Loss Compensation using Analog Pre-emphasis

Analog Pre-Emphasis

Tx Template Concerns

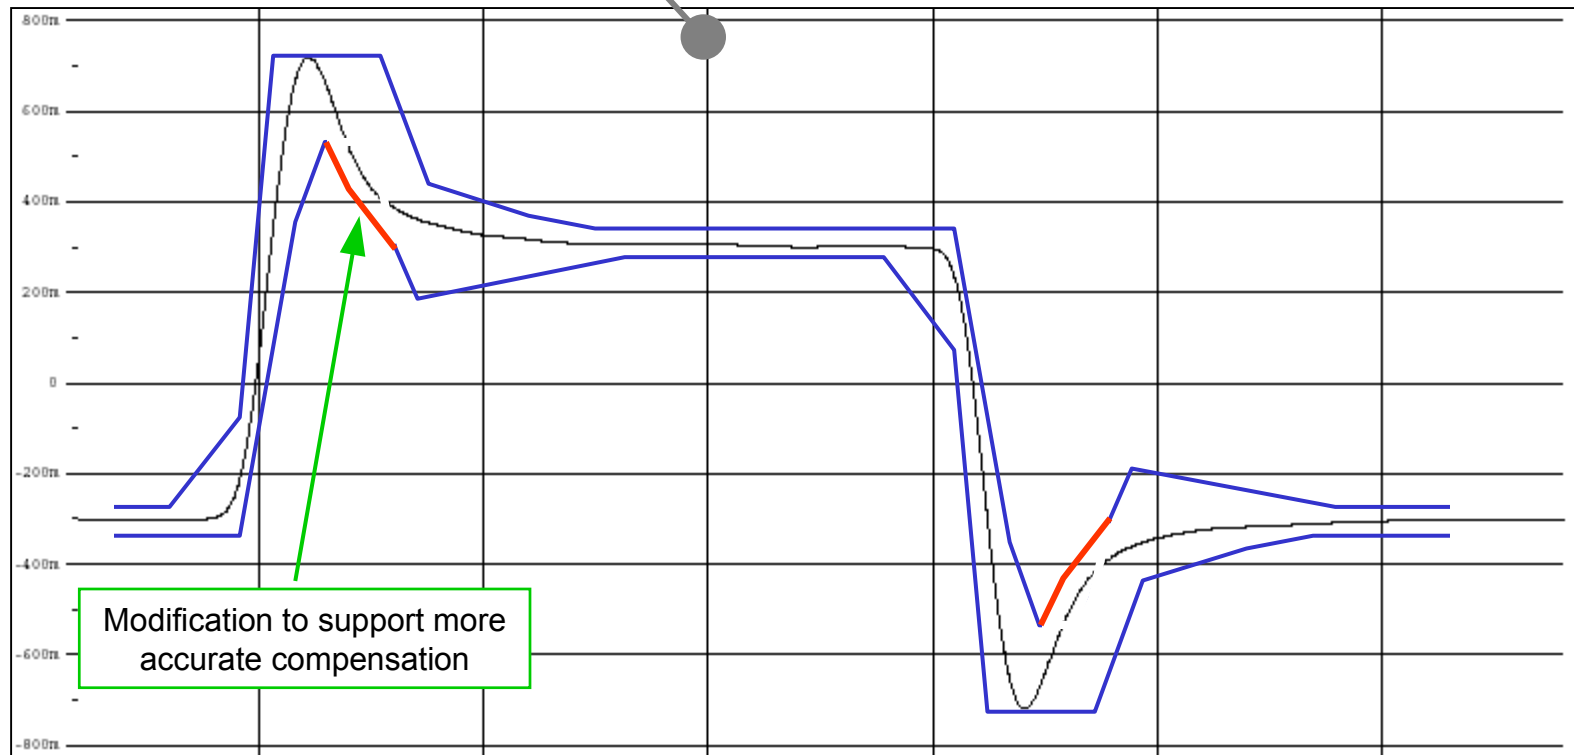
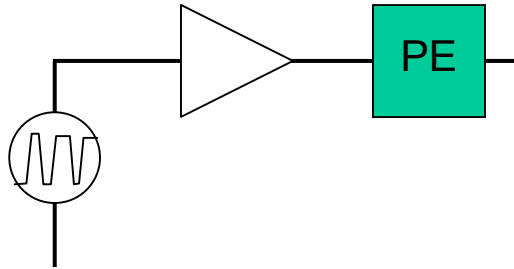
Existing Tx Template is crafted for 1-bit wide pre-emphasis and it is implementation specific.

This excludes more accurate solutions:

Fractional delay/sub-bit timing

Analog filter

Modify the Tx Template to accommodate analog pre-emphasis.

Do not exclude a viable and simple technical solution.

Transmitter Template

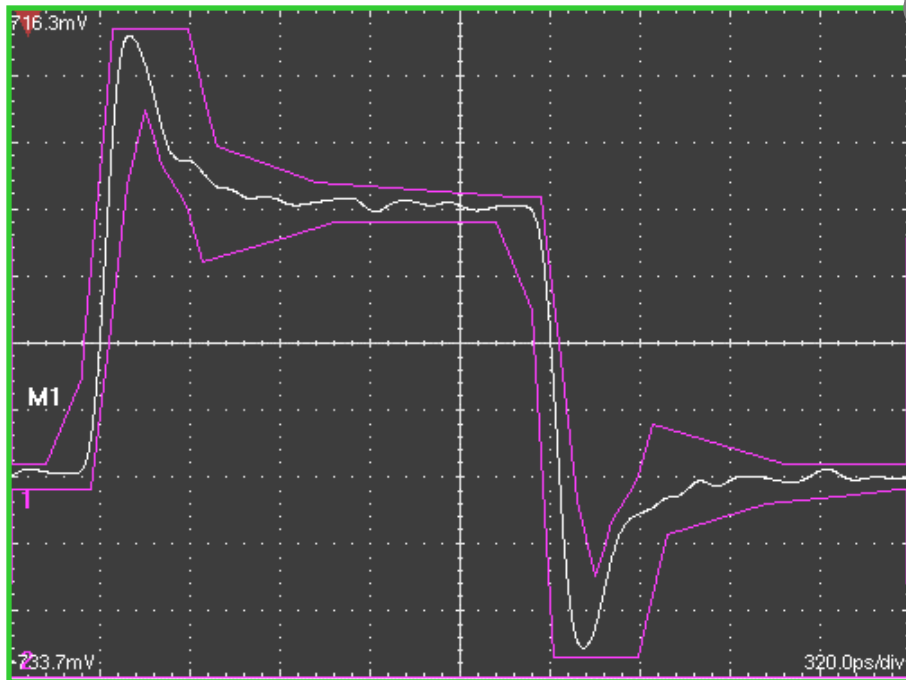
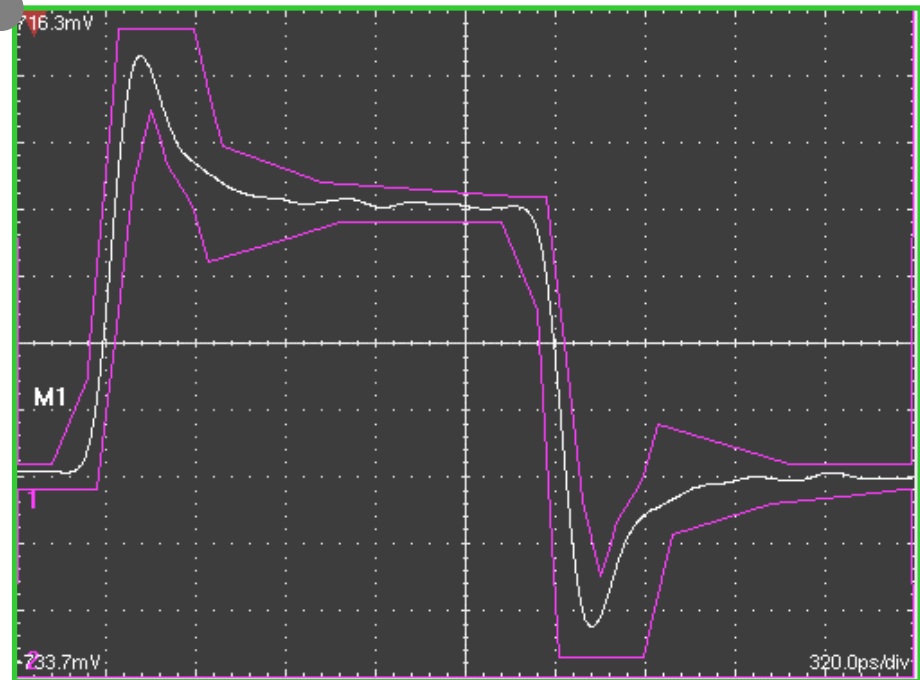
Scope bandwidth should be included in the template test requirements.

- Too high of a bandwidth might show more meaningless aberrations that cause violations.
- Too low of a bandwidth might hide meaningful violations.

The “Steve+Ze’ev+Clark” template is shown above. This is a consolidation of proposed modifications complied by Ze’ev Roth.
